**Subject** ▶ Change of Hammer, Armature, etc.

**For Models** ▶ 6932FD

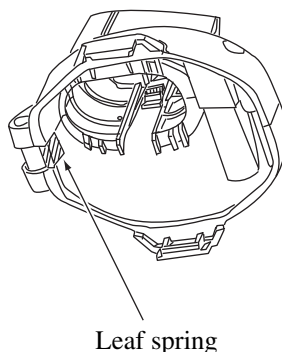
1. Hammer has been changed.
2. The number of winding armature coil has been changed from 13 to 12.
3. Leaf spring has been added as illustrated below.
